Re: Initial Submission Review: 60th Avenue at Box Elder – Infrastructure Site Plan
Application Number: DA-1478-14
Case Numbers: 2024-6039-00

INITIAL SUBMISSION REVIEW

BOX ELDER SUBDIVISION FILING NO.2 INFRASTRUCTURE SITE PLAN

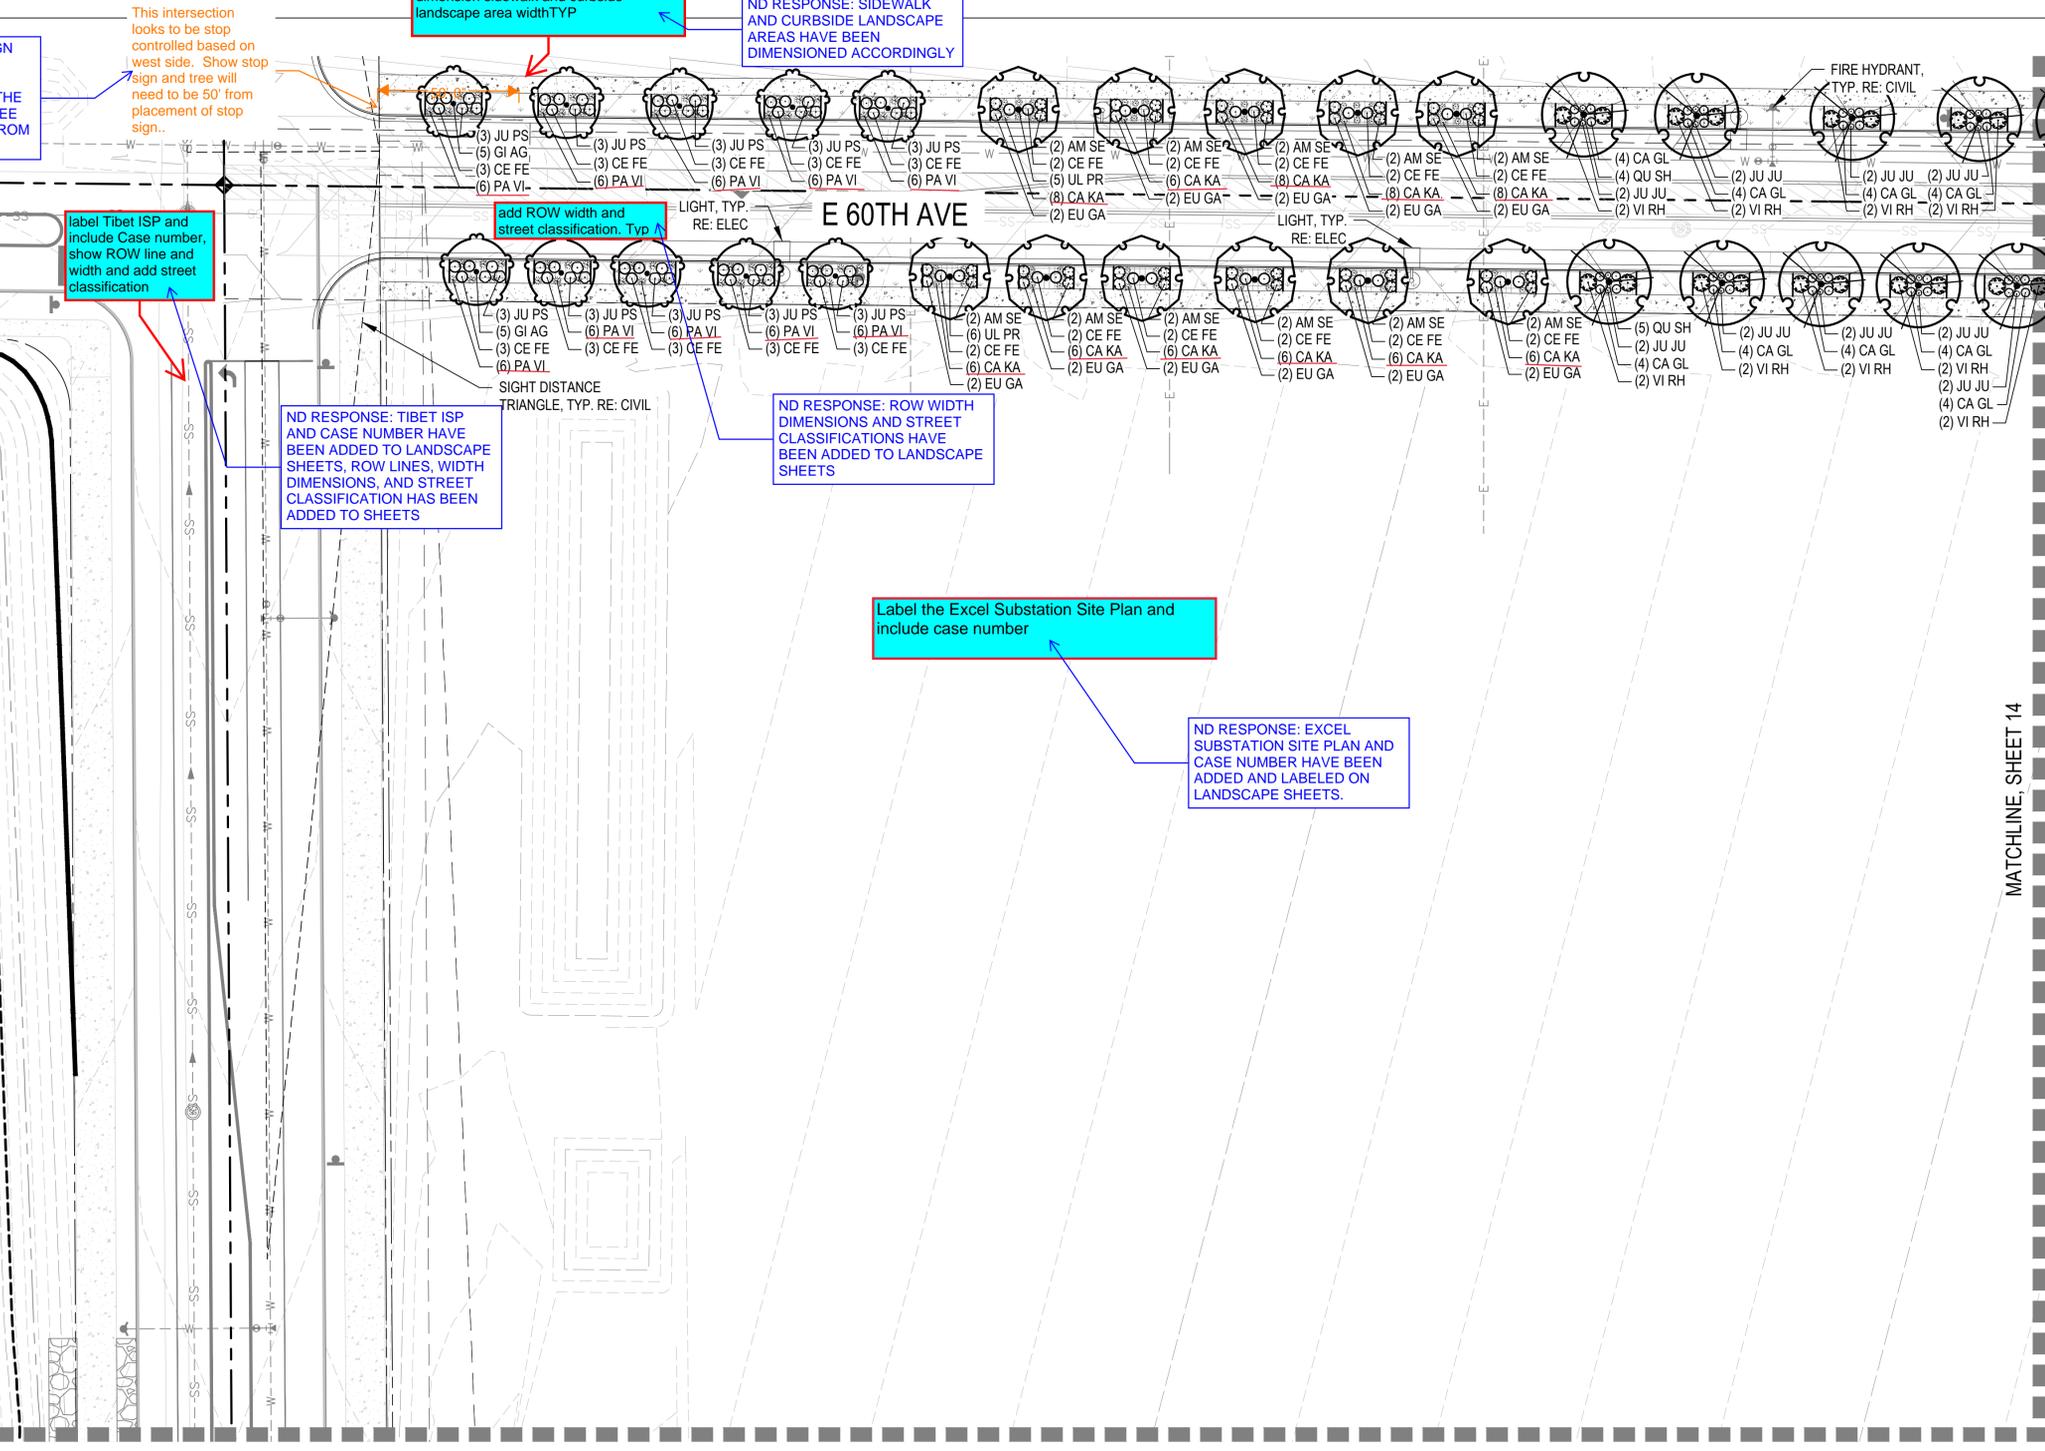
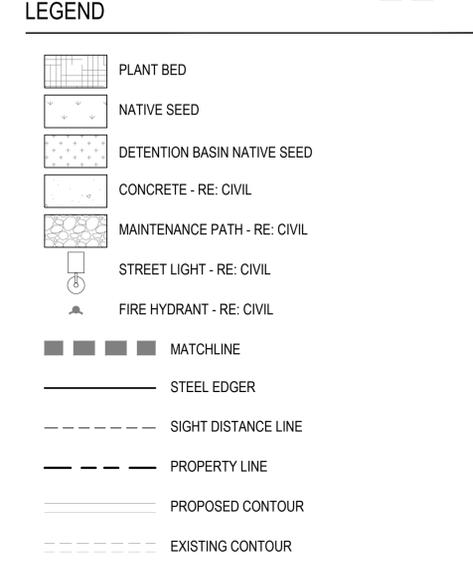
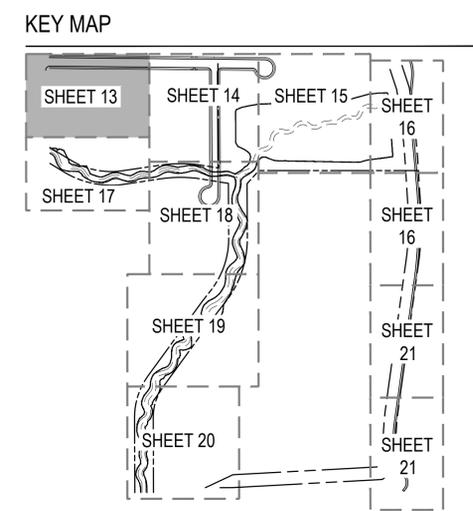
label Tibet ISP and include Case number, show ROW line and width and add street classification

add ROW width and street classification. Typ

Label the Excel Substation Site Plan and include case number

ND RESPONSE: SIDEWALK AND CURBSIDE LANDSCAPE AREAS HAVE BEEN DIMENSIONED ACCORDINGLY

ND RESPONSE: TIBET ISP AND CASE NUMBER HAVE BEEN ADDED TO LANDSCAPE SHEETS, ROW LINES, WIDTH DIMENSIONS, AND STREET CLASSIFICATION HAS BEEN ADDED TO SHEETS

ND RESPONSE: EXCEL SUBSTATION SITE PLAN AND CASE NUMBER HAVE BEEN ADDED AND LABELED ON LANDSCAPE SHEETS.

Sheet Number:
LANDSCAPE PLAN
 15

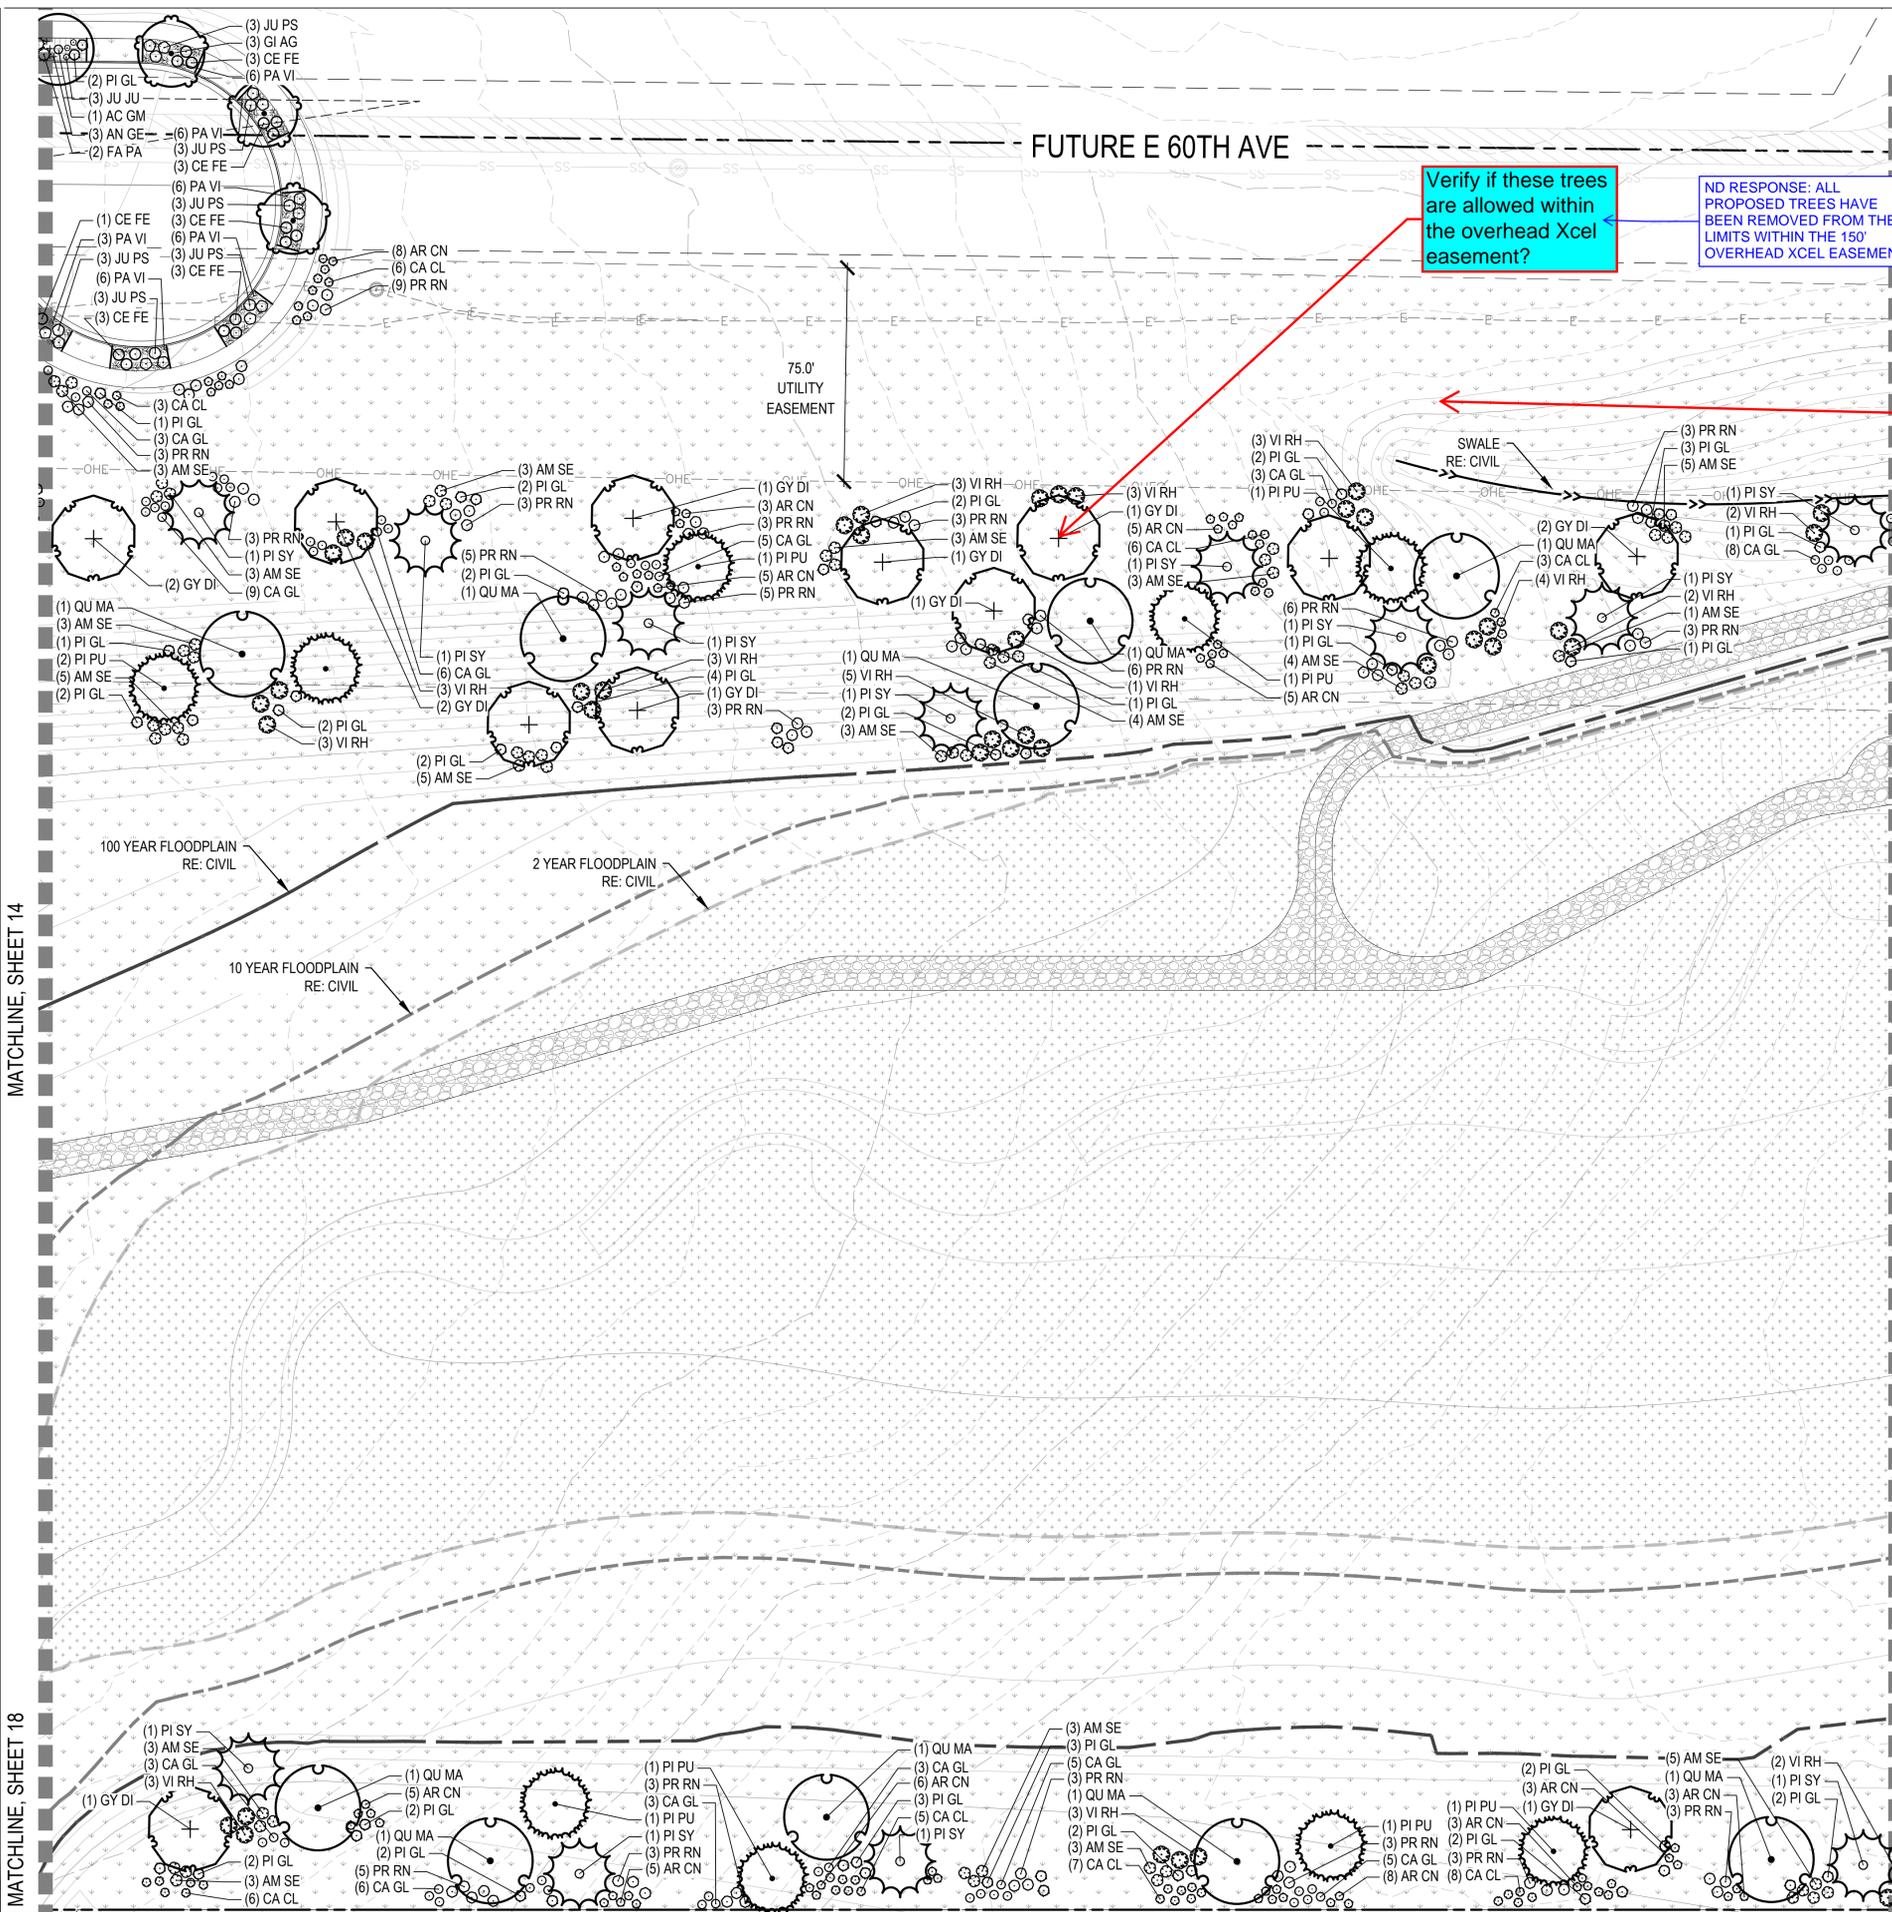
Verify if these trees are allowed within the overhead Xcel easement?

Label and dimension the 150' overhead Xcel easement

ND RESPONSE: OVERHEAD XCEL EASEMENT HAS BEEN DIMENSIONED AND LABELED ACCORDINGLY ON LANDSCAPE SHEETS

Sheet Number:
LANDSCAPE PLAN
16

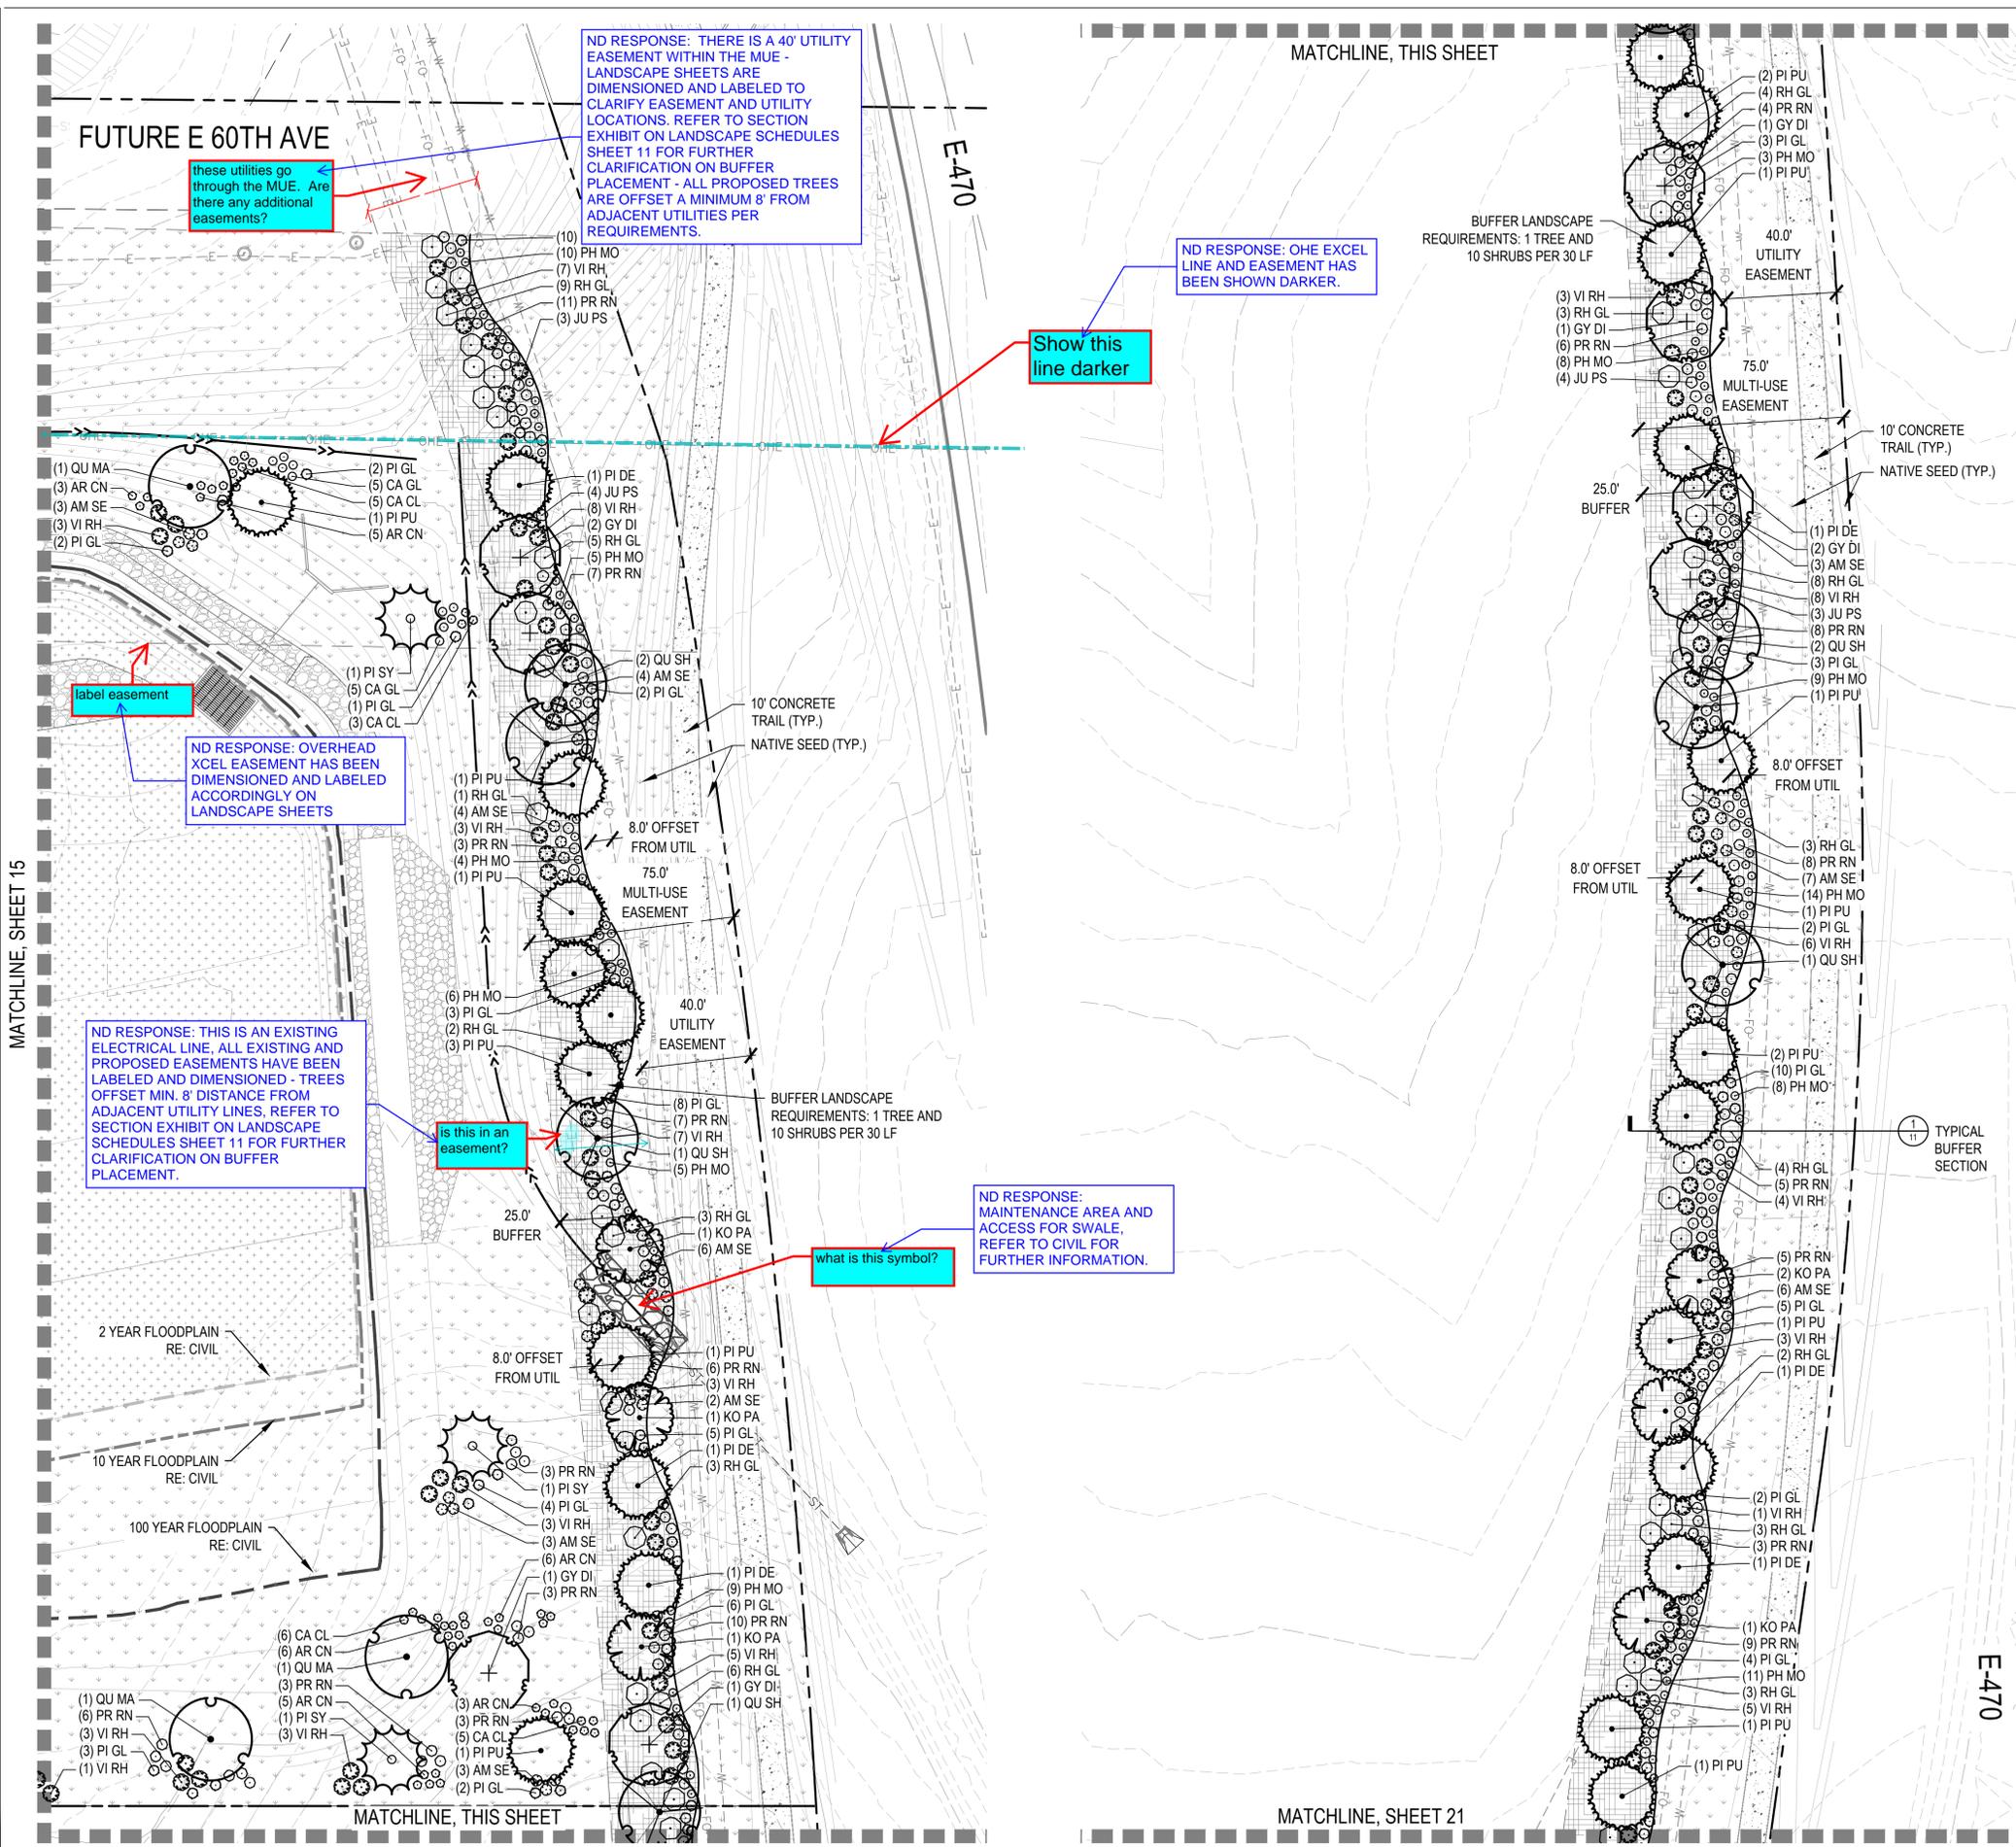
Show this line darker

these utilities go through the MUE. Are there any additional easements?

ND RESPONSE: THERE IS A 40' UTILITY EASEMENT WITHIN THE MUE - LANDSCAPE SHEETS ARE DIMENSIONED AND LABELED TO CLARIFY EASEMENT AND UTILITY LOCATIONS. REFER TO SECTION EXHIBIT ON LANDSCAPE SCHEDULES SHEET 11 FOR FURTHER CLARIFICATION ON BUFFER PLACEMENT - ALL PROPOSED TREES ARE OFFSET A MINIMUM 8' FROM ADJACENT UTILITIES PER REQUIREMENTS.

ND RESPONSE: OVERHEAD XCEL EASEMENT HAS BEEN DIMENSIONED AND LABELED ACCORDINGLY ON LANDSCAPE SHEETS

ND RESPONSE: THIS IS AN EXISTING ELECTRICAL LINE, ALL EXISTING AND PROPOSED EASEMENTS HAVE BEEN LABELED AND DIMENSIONED - TREES OFFSET MIN. 8' DISTANCE FROM ADJACENT UTILITY LINES, REFER TO SECTION EXHIBIT ON LANDSCAPE SCHEDULES SHEET 11 FOR FURTHER CLARIFICATION ON BUFFER PLACEMENT.
